Access Compliance Report

Public Rights-of-Way

(Curb Ramps)

Intersection ID: 10031995	Main Street: MONROE_RD	Cross Street: N/A	Location: SW
ADA ID: 05D164C8AAFC	Ramp Type: PerpDiag	Initial Pass/Fail: Fail	Overall Compliance: No
			Severity Score: 26.25

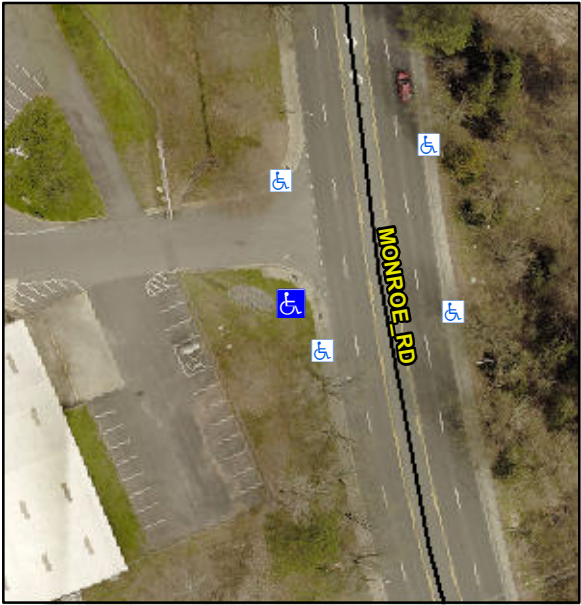
Codes/Mitigation Info/Possible Solution		Field Measurements/Component Compliance					
	Possible Solutions:	Compliance	Description	Data	Compliance	Description	Data
	Remove & Replace Curb Ramp With Two New Directional Ramps or Equivalent.	N/A	Ramp Length (in)	69.0	No	Ramp Slope (%)	14.0
		Yes	Ramp Width (in)	48.0	No	Ramp XSlope (%)	2.7
		N/A	Flare Type LT	N/A	N/A	Flare Type RT	N/A
		N/A	Flare Slope LT (%)	N/A	N/A	Flare Slope RT (%)	N/A
		N/A	Flare Traversable LT?	N/A	N/A	Flare Traversable RT?	N/A
		N/A	Landing Length (in)	N/A	N/A	DWS Provided?	N/A
		N/A	Landing Width (in)	N/A	N/A	DWS Contrast?	N/A
		N/A	Landing Slope (%)	N/A	N/A	DWS Length (in)	N/A
		N/A	Landing X Slope (%)	N/A	N/A	DWS Full Width?	N/A
		N/A	Landing Curb? (Y/N)	N/A	N/A	DWS Offset (in)	N/A
		N/A	Shared Landing?	N/A			
		N/A	Gutter Ponding?	N/A	N/A	Gutter Slope (%)	N/A
		N/A	Gutter Lip Ht (in)	N/A	N/A	Gutter X Slope (%)	N/A
		N/A	Painted X Walk1?	No	N/A	Painted X Walk2?	No

X Walk 1 Direction	To E		X Walk 2 Direction	To N
		N/A	X Walk 1 Width (in)	N/A	N/A	X Walk 2 Width (in)	N/A
			X Walk 1 Slope (%)	0.9		X Walk 2 Slope (%)	2.5
			X Walk 1 X Slope (%)	0.8		X Walk 2 X Slope (%)	0.3
		N/A	Ramp inside XWalk1?	N/A	N/A	Ramp inside XWalk2?	N/A
<p>Surveyor Notes:</p> <p>N/A</p> <p>PROW/ADA:</p> <p>Not Found, R304.2.2, R304.5.3</p>			Road Slope (%)	2.6	N/A	Clear Space?	N/A
			Road X Slope (%)	2.1	N/A	Clear Space to XWalk (in)	N/A
		N/A	Any Obstructions?	N/A	N/A	Storm Grate/Utility Hazard?	N/A
			Obstruction Type			Storm Grate/Utility Type	
					N/A		N/A
					Yes	Surface Condition? (G/P)	Good
Total Cost:		\$	3200.00
